Stanford House, 9 Nestles Avenue, Hayes UB3 – Daylight, Sunlight & Overshadowing

In addition we have been provided with a letter of 9th November 2020 prepared by Lambert Smith Hampton following a review of our detailed report of July 2020. The Lambert Smith Hampton letter raised some queries in respect of our report. We have provided further clarification in respect of these elements below and additional technical information is attached where useful to aid in addressing these queries.

Revised western elevation indicating area of proposed changes.

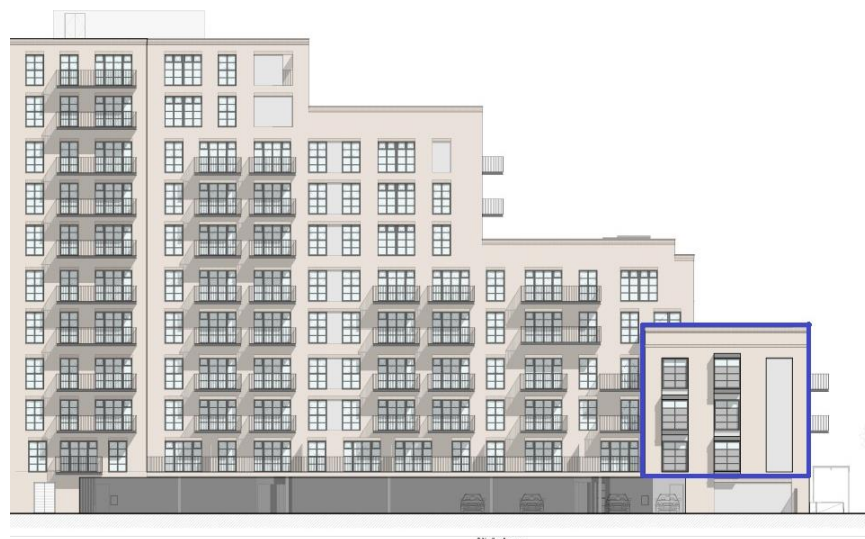
These changes include the redesign and removal of some windows to the southwestern flank elevation where it is closest to the neighbouring site at 7 Nestles Avenue. Glazed elements have been removed additional return windows and a staggered 'bay' element added to retain good daylight levels to these units. The areas of these changes are highlighted below:

Title First Floor
Room Layout

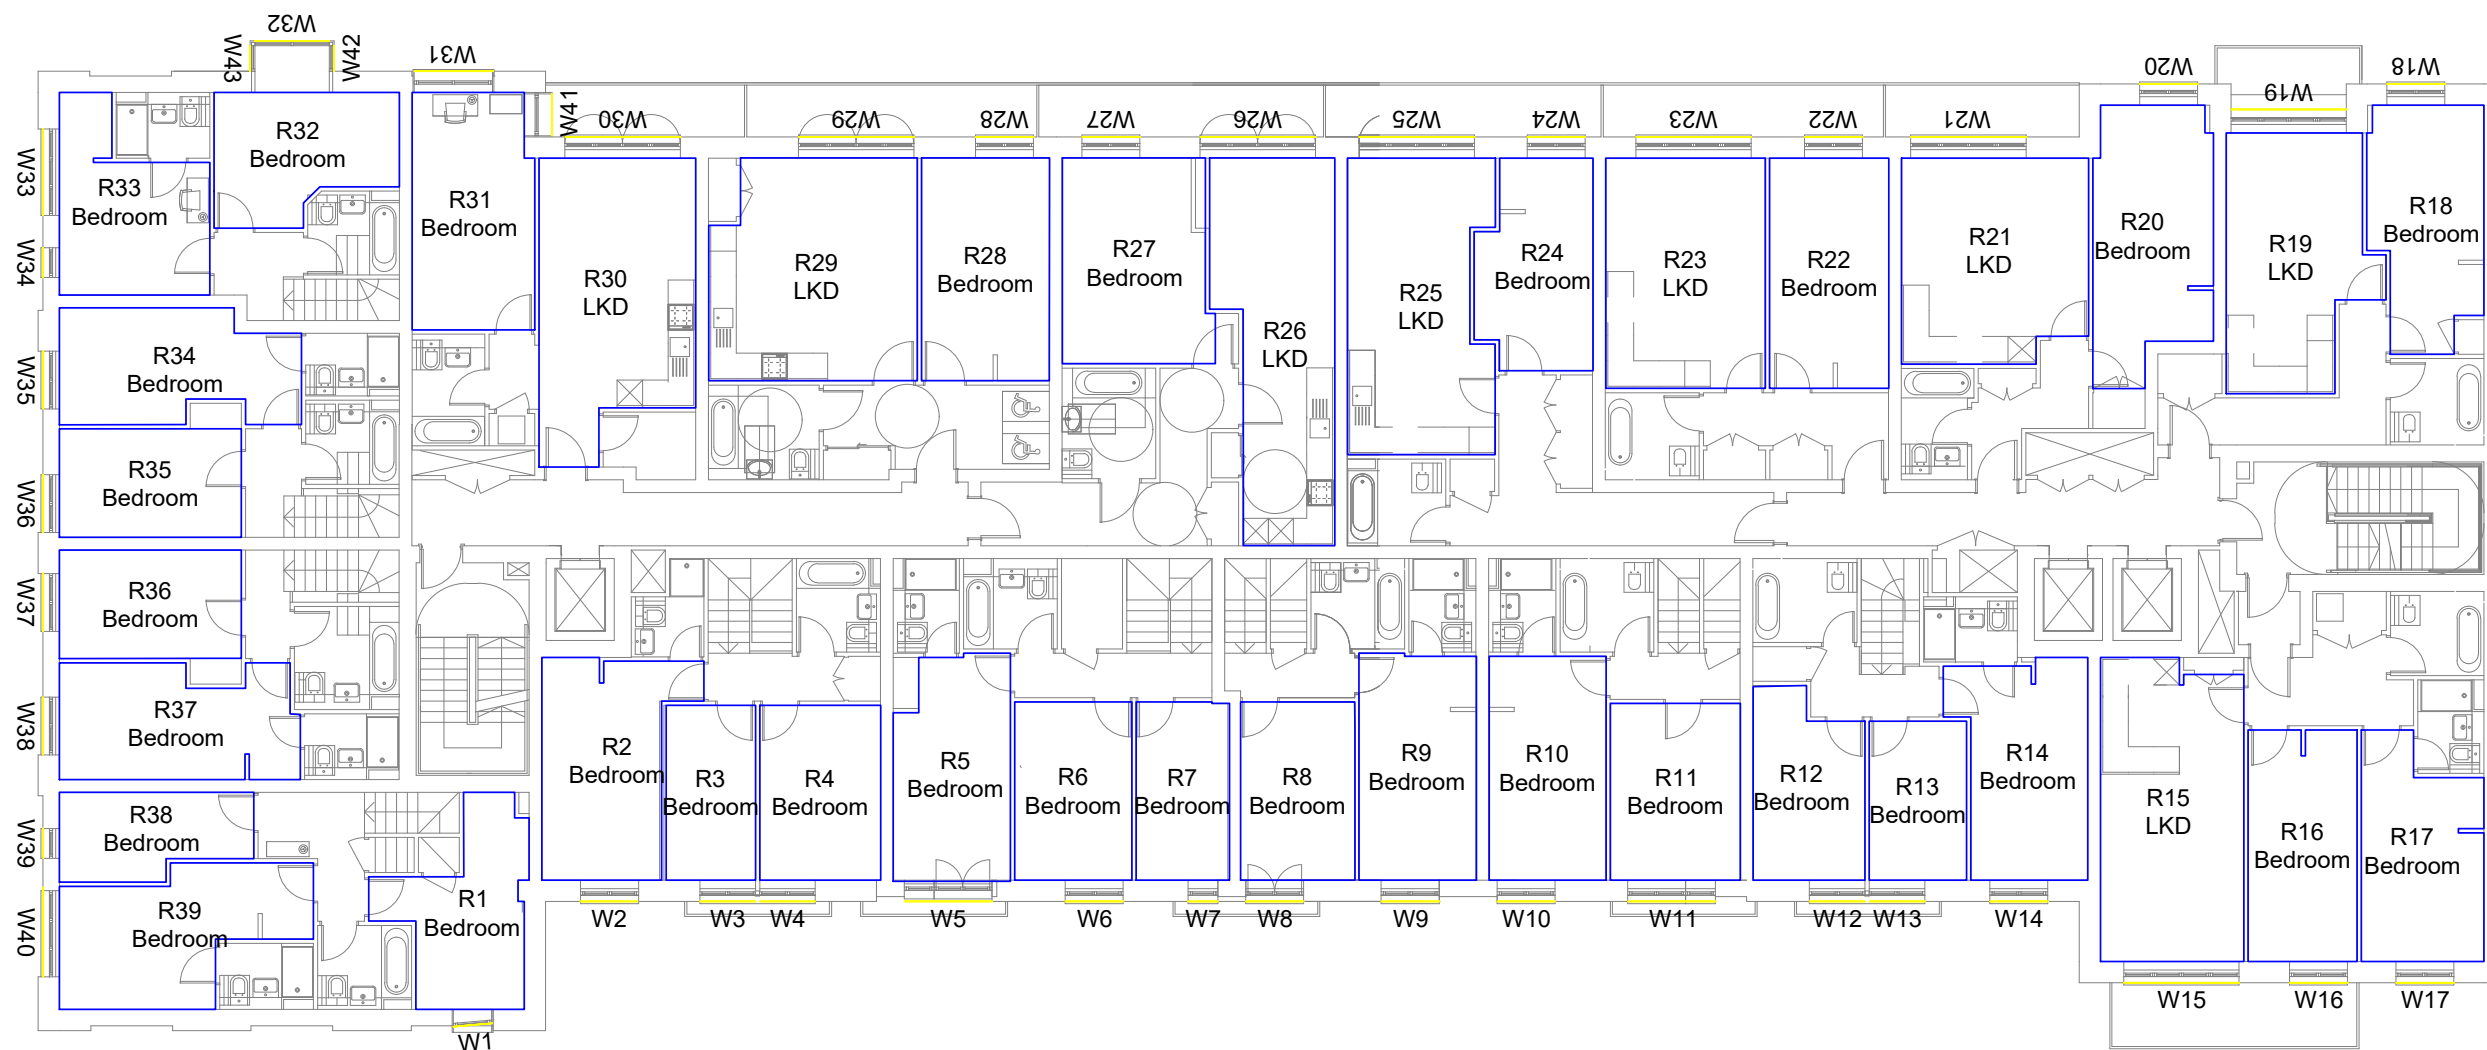
The results of our internal daylight assessment show that the rooms affected by the revisions to their glazing continue to meet the ADF targets for their specific room use. These rooms are identified as First Floor R31 & R32, Second Floor R29 & R30 and Third Floor R29 & R30.
